2. Subdivision and Land Development Bylaw – technical issues

(Report from Keith Hovell, Planning Consultant)

Two submissions have been received on technical issues associated with the proposed Subdivision and Land Development Bylaw and these are considered below.

Figure B18 - D17-1 Standard House Connection Details

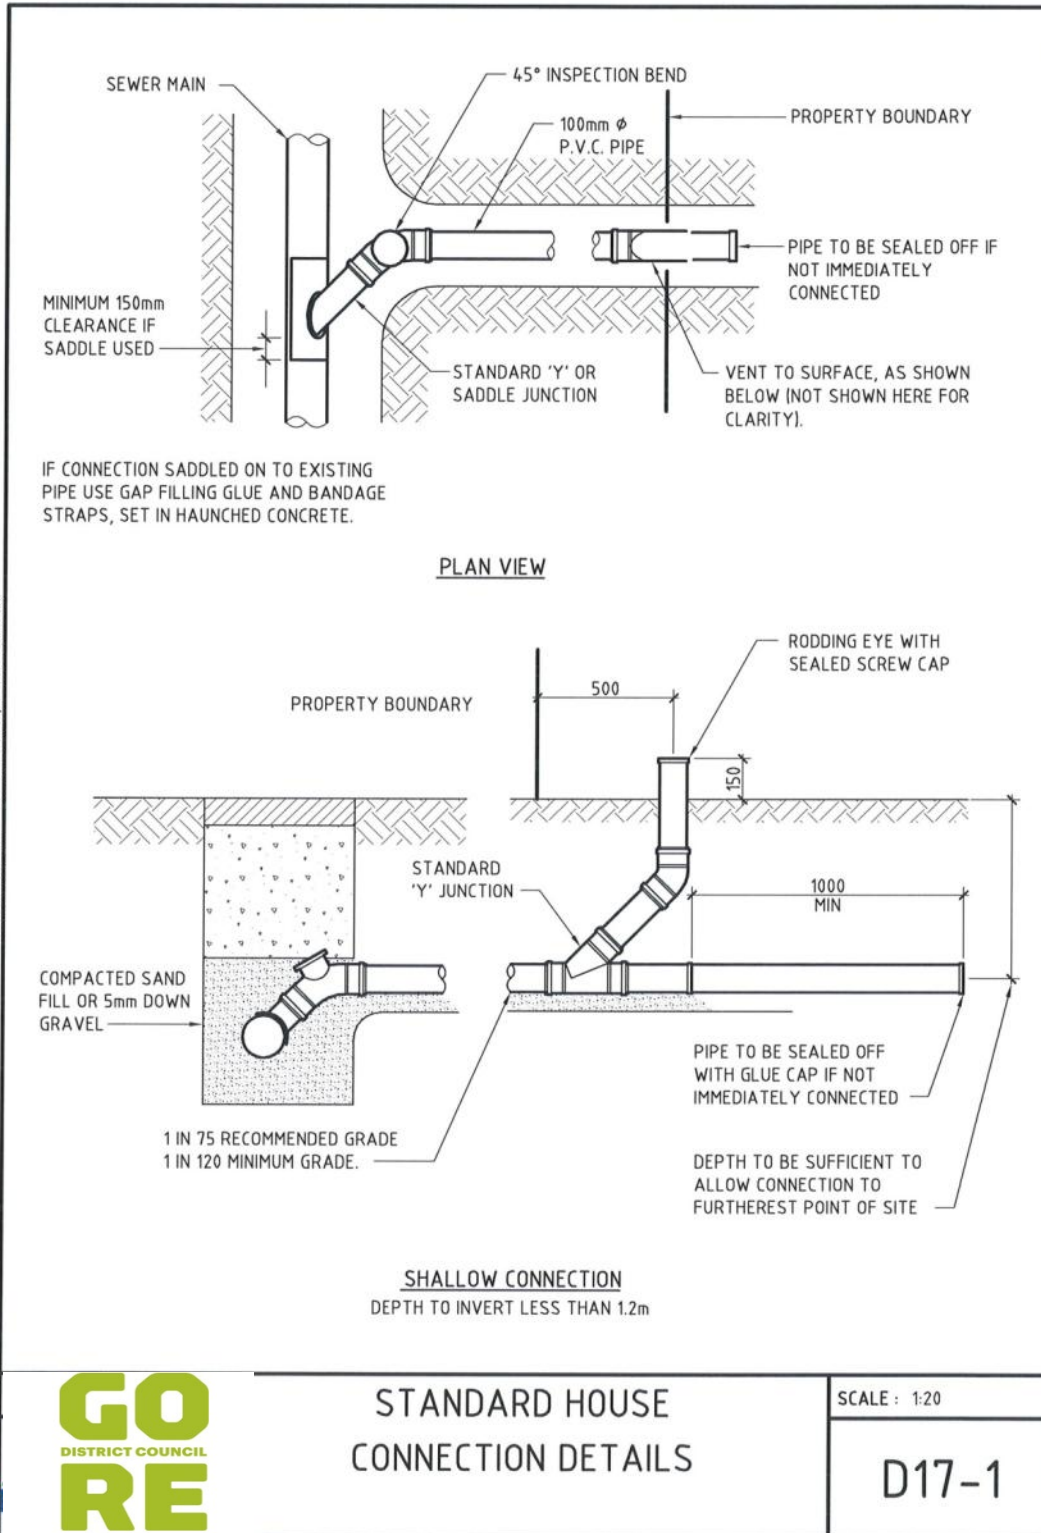
<p>12 Bylaw provision and Issue D17-1 Standard house connection detail shows raised PVC rodding eyes which will be vulnerable to damage.</p>	<p>Requested Change The detail should be altered to show a flush plastic box and lid similar to a water meter box. Reason Raised plastic pipes will be vulnerable to damage allowing surface water, soil and other undesirable material to enter the sewer. The plastic boxes would protect the rodding eye access and provide for ease of location.</p>
<p>Provision Subject to Submission</p>

A valid issue is raised and it is recommended that the diagram be amended to show a flush plastic box and lid similar to a water meter.

Sheet **R10**

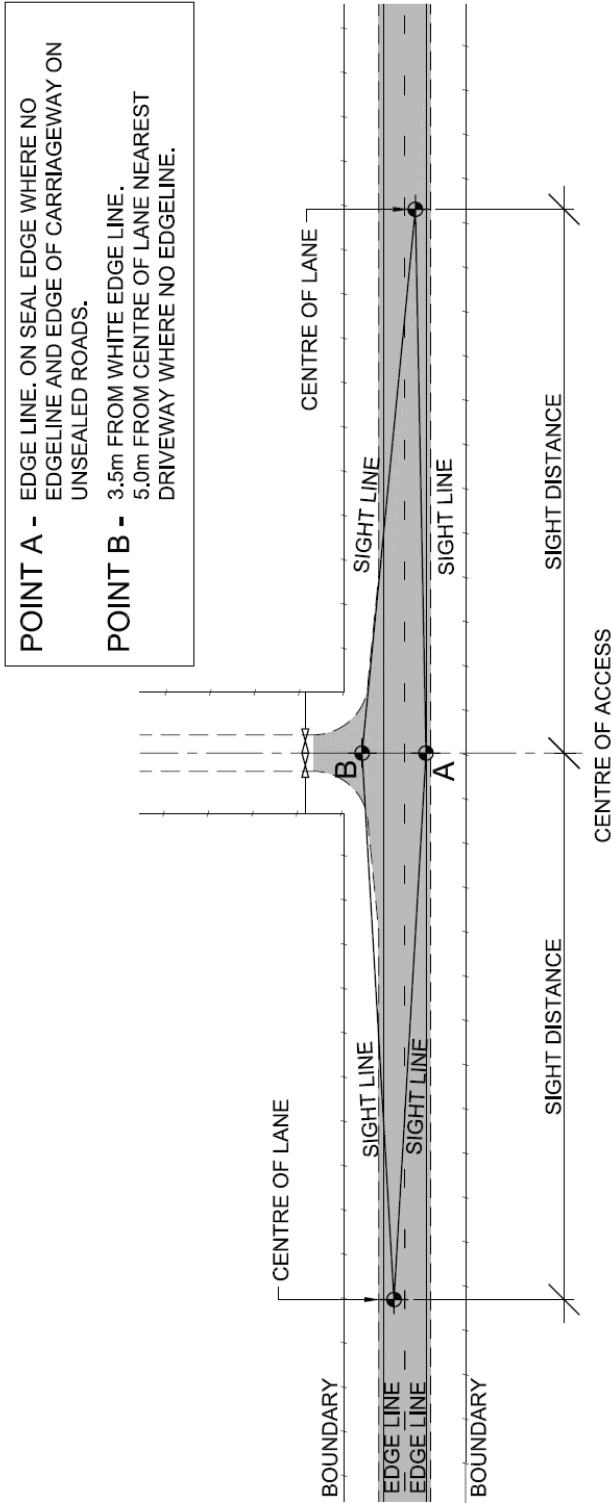
13 Bylaw provision and Issue

R10

The image is blurry and difficult to read.

Requested Change

Provide a better-quality image.

A number of diagrams in the proposed Bylaw are copied from the existing Bylaw and other sources. These all require replacement with better quality images and that will be done as part of the final document.

Tables 3.3A (p66) and Tables 3.3B & 4.3C (p67) refer to *Standard Drawings R13 and R14* – these drawings don't appear in Appendix B

The omission is noted and it is recommended that Standard Drawings R13 and R14 be included in the final Bylaw document.
